Village Square
Residential and Commercial Development
3095 Albany Post Road
Village of Buchanan, NY

Project: Village Square – Buchanan, NY
Scope: Response to Comments of David B. Smith of July 26, 2023
Village Planning Advisor
Date: August 8, 2023
By: Ralph G. Mastromonaco, PE

Project: Village Square – Buchanan, NY
Scope: Response to Comments of NYS DEC of April 12, 2023
Date: August 7, 2023
By: Ralph G. Mastromonaco, PE

Jeff Faiella, Chairman and Members
Village of Buchanan Planning Board
Municipal Building
236 Tate Avenue
Buchanan, NY 10511

1 Site Lighting Plan
 Scale 1" = 20'-0"

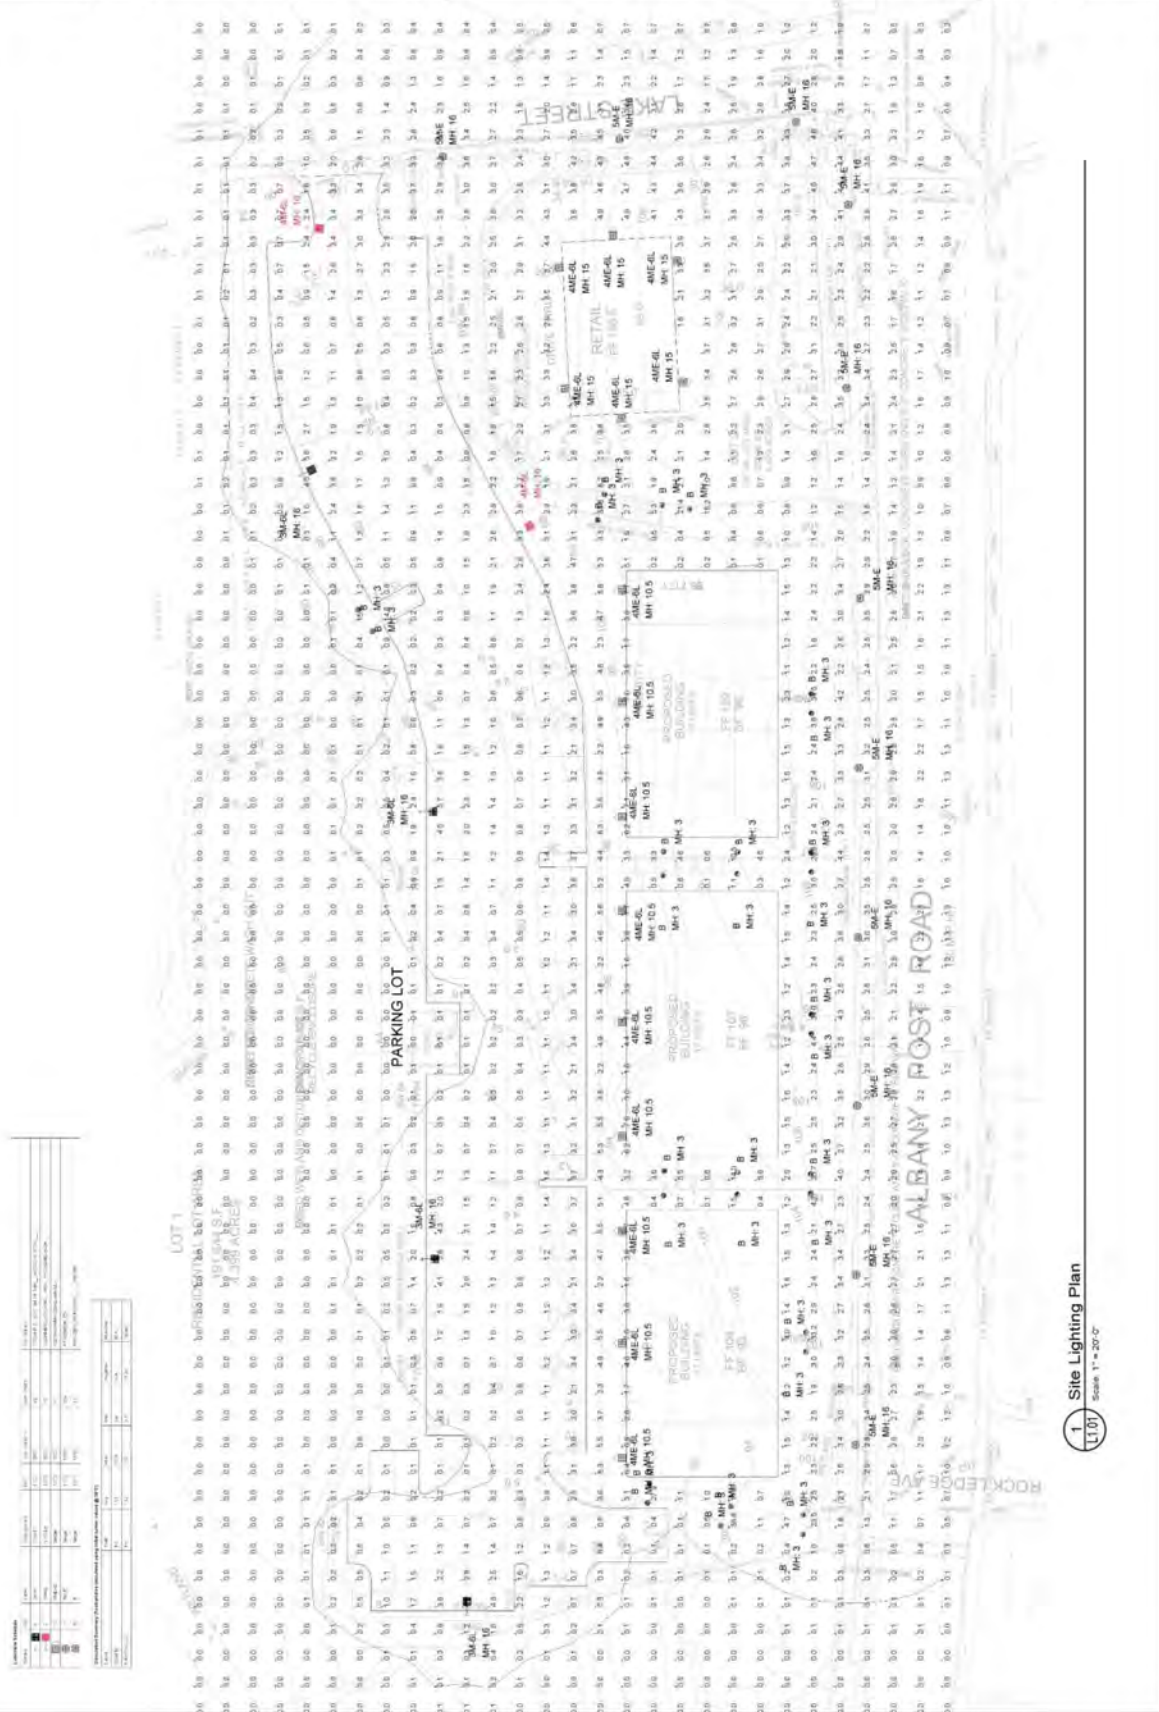
Comment: Lighting

- (1) The Applicant has provided a lighting plan with illumination data
- (2) The lighting shown is shielded from offsite areas and the sky.
- (3) The lighting fixtures are a part of the Site Plan while the illumination data are included as an exhibit only and not a part of the Site Plan set.

Figure: Plan View - Areas of Existing 30% Slope

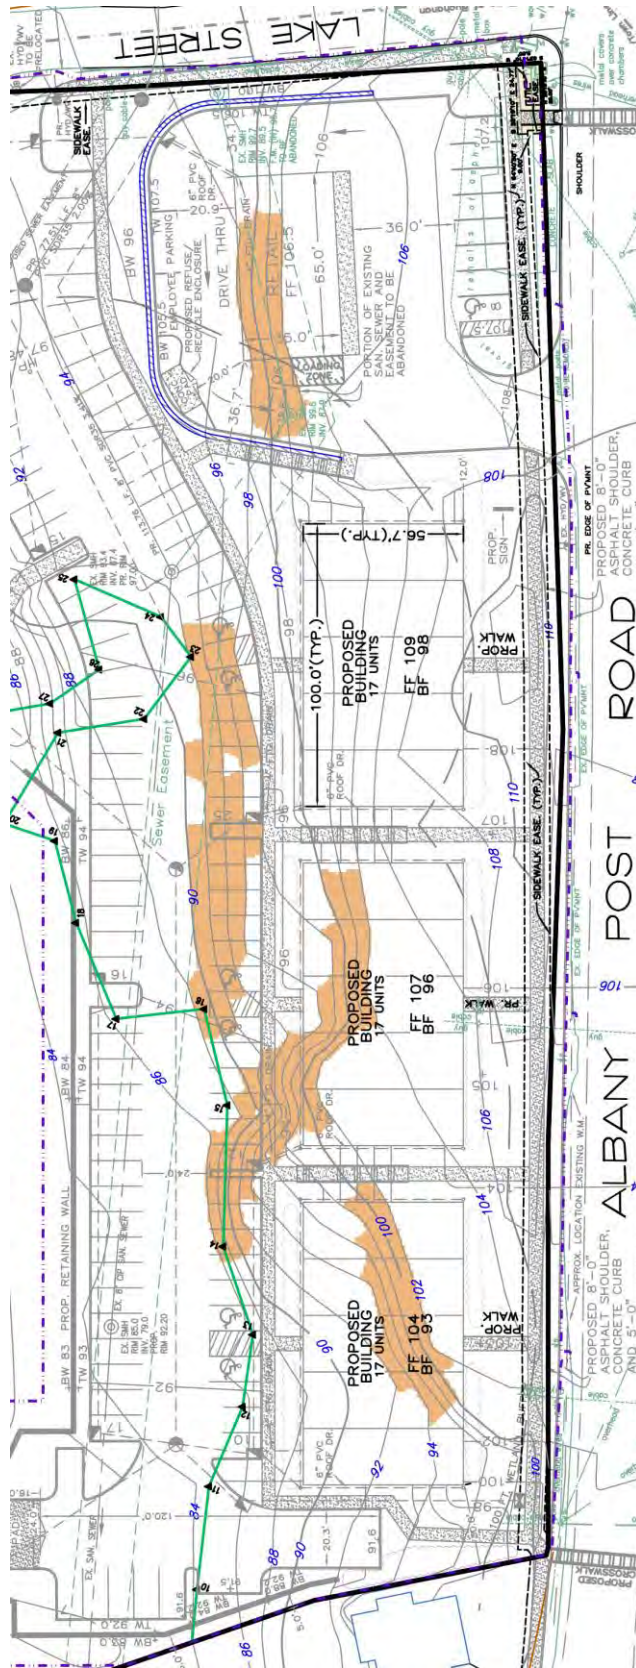
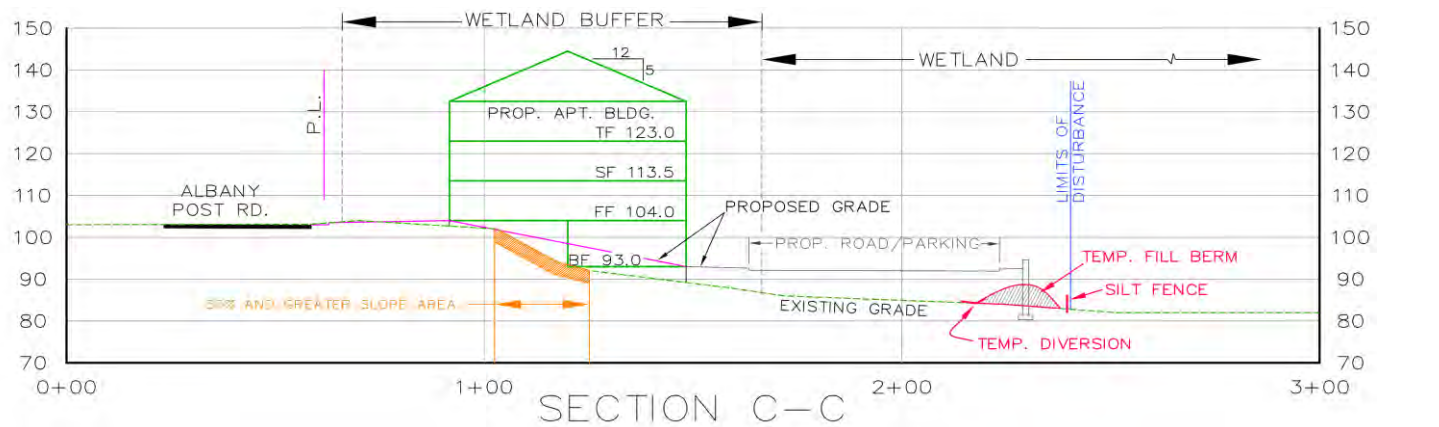
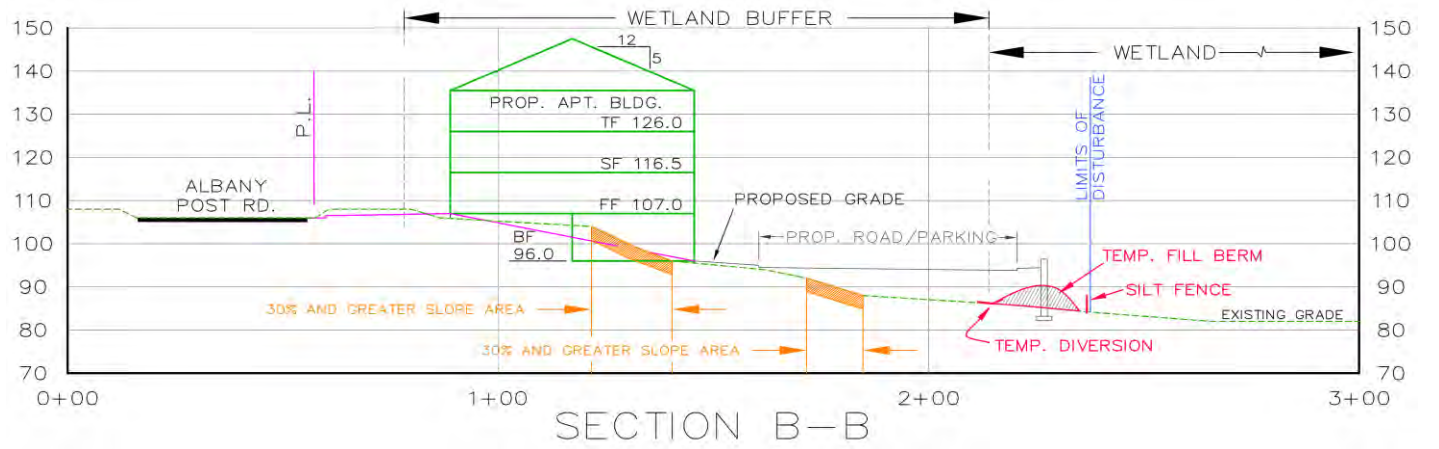
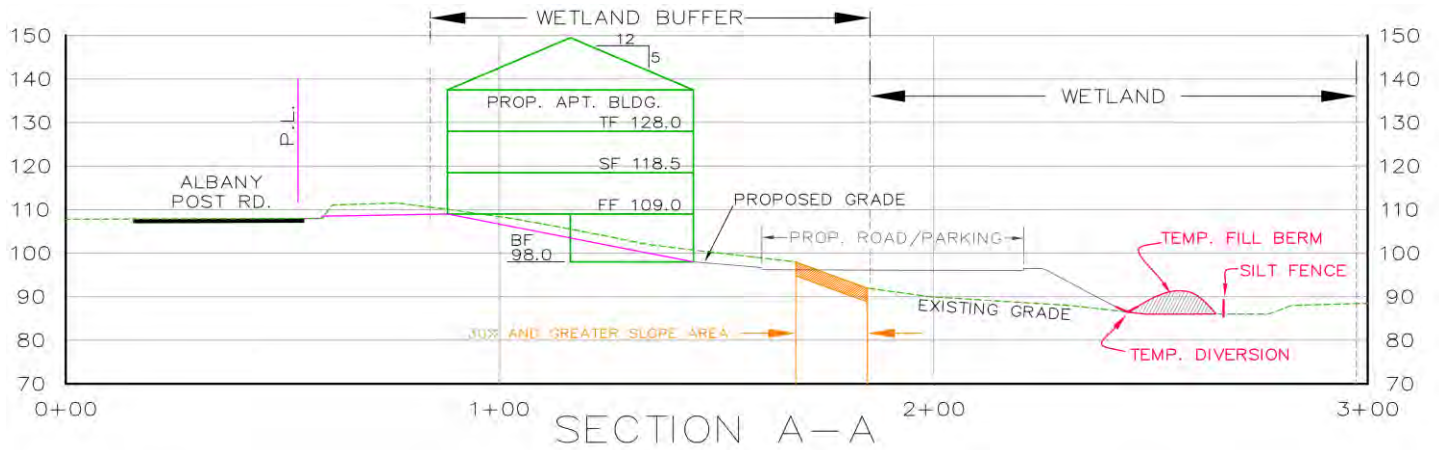
12. More than 30% of the site's excessively steep slopes are proposed to be disturbed. A before and after visual impact analysis and a report prepared by a NYS licensed geotechnical engineer indicating the impacts of the disturbance to the steep slopes and a slope stability analysis should be provided, in accordance with the revised Village Code.

Response: Our office provided a detailed analysis to the Village Engineer which we believe was acceptable.

1 Monument Sign Renderings
A5.01 Scale: NTS

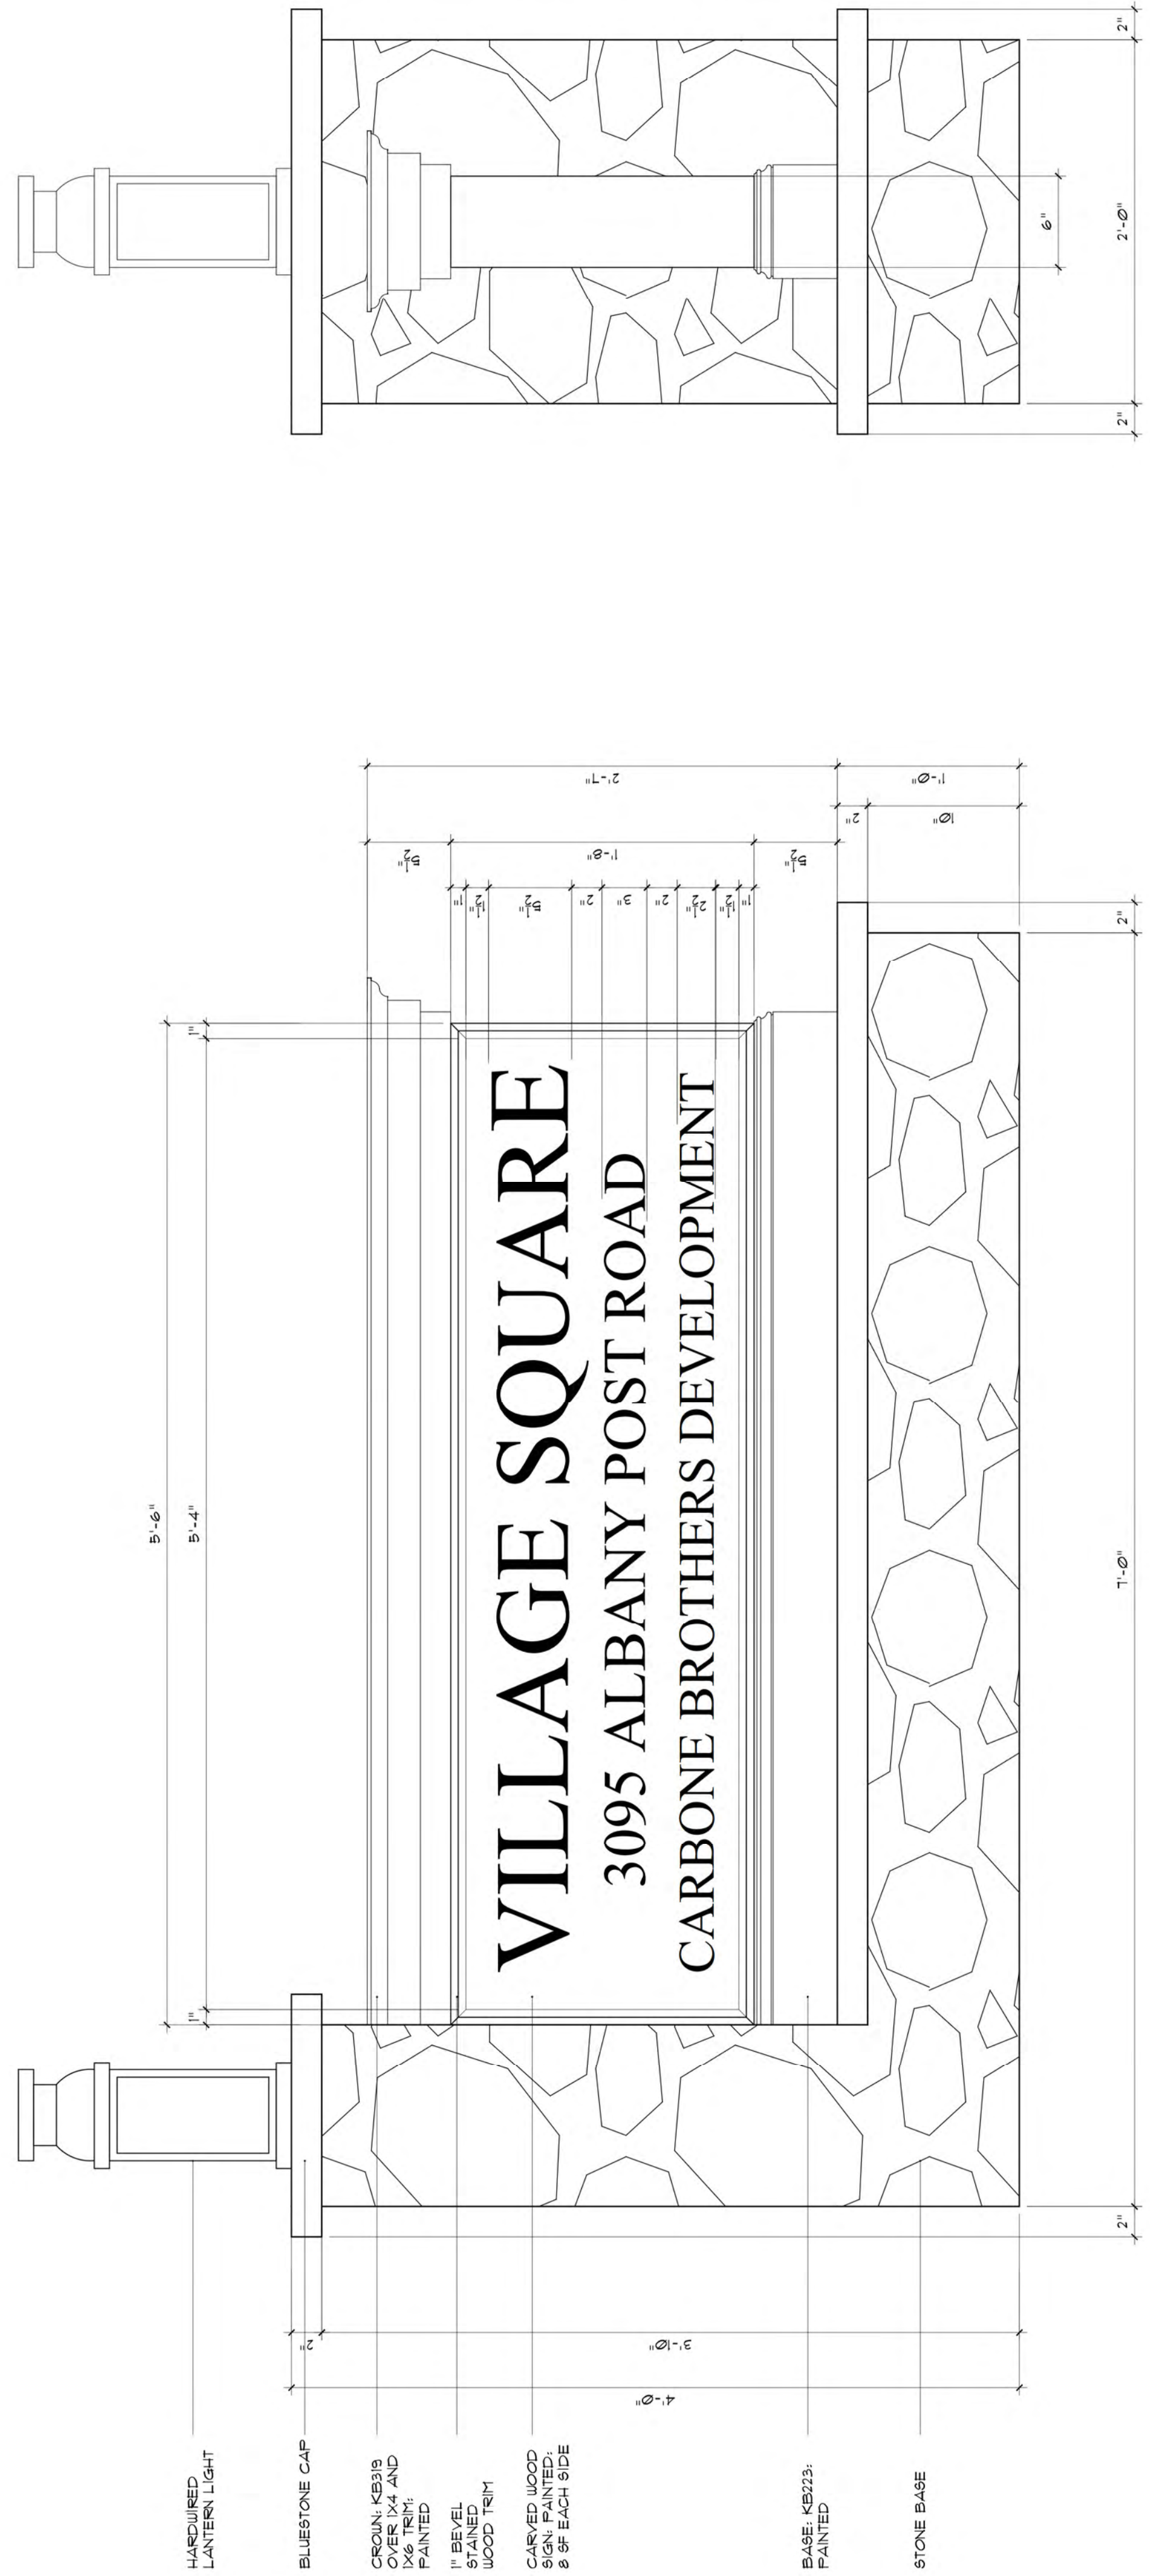
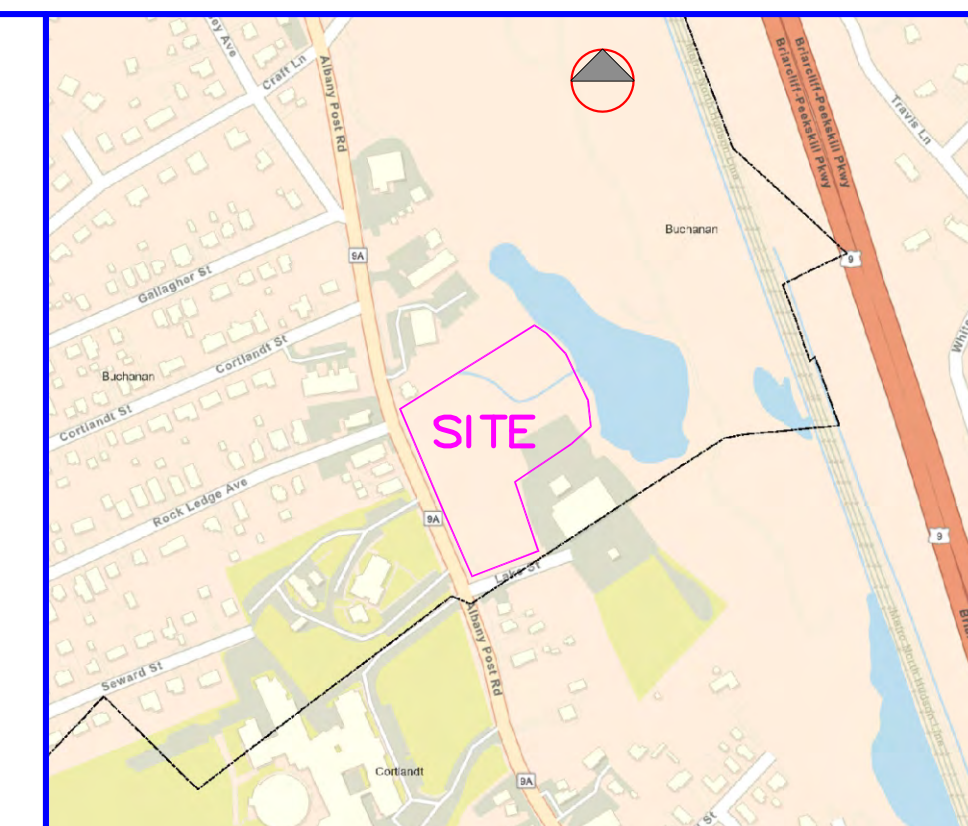
3. As previously mentioned, all right-of-way improvements shall conform to Village and NYSDOT standards as applicable. Additionally, a proposed signage plan will be required. Signage visible and located along the NYSDOT right-of-way will need to be approved by the NYSDOT. Signage and right-of-way details have not been provided.

Response: The only signage proposed is a monument sign of the Village Square to be located at the south side of the residential buildings. No signs are proposed in relation to NYS DOT. Any signs for the commercial property will be provided at the Site Plan approval for the commercial lot.
